# LEAVENWORTH PRESERVATION COMMISSION

REGULAR SESSION Wednesday, January 3, 2024 6:00 p.m.

State Law Review KSA 75-2724 1128 3<sup>rd</sup> Avenue January 3, 2024

A State Law review (KSA 75-2724) for proposed modifications to the property located at 1128 3<sup>rd</sup> Avenue, a property located in the Third Avenue Historic District, under the Secretary of the Interior's Standards for Rehabilitation. The scope of work includes the installation of 31 roof-mounted solar panels.

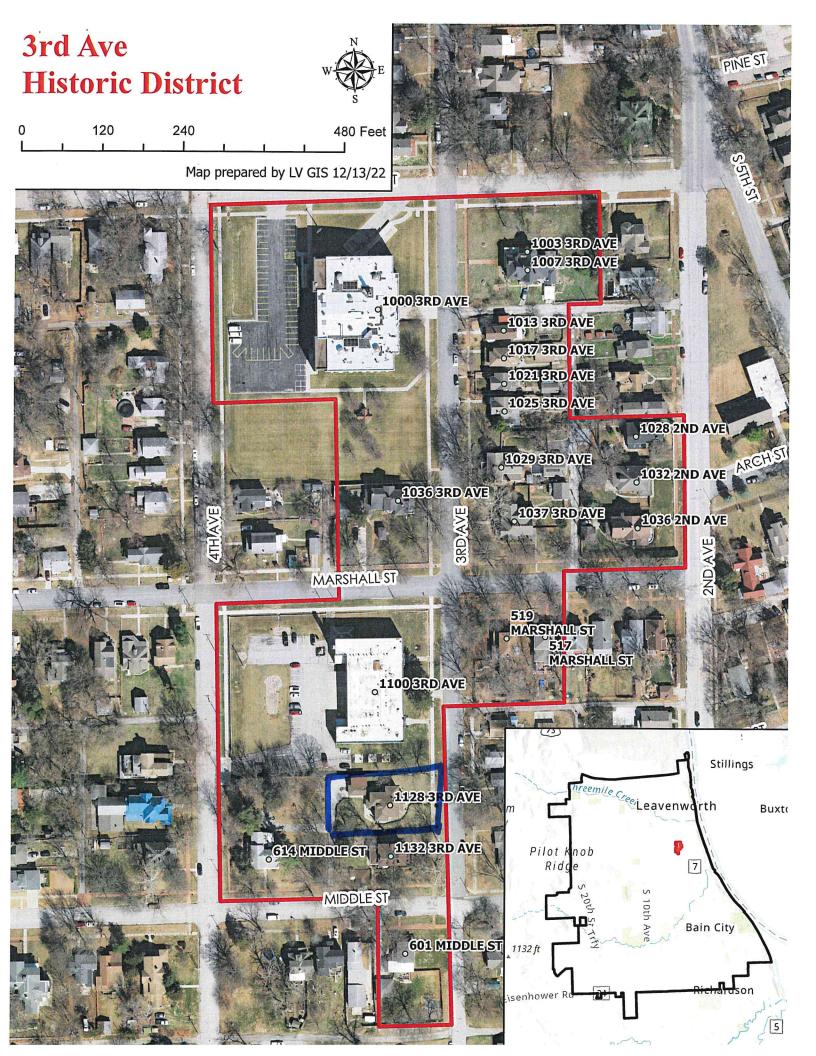
The proposed 31 roof-mounted solar panels are proposed on three sides of the primary house hipped roof (east, south, and west side), including the front facing roof and on both sides of the gabled roof attached garage.

The proposed roof mounted solar panels on the front (East) side will be highly visible from the street, altering the historic character.

The proposed solar panels will be differentiated but not compatible on the front side.
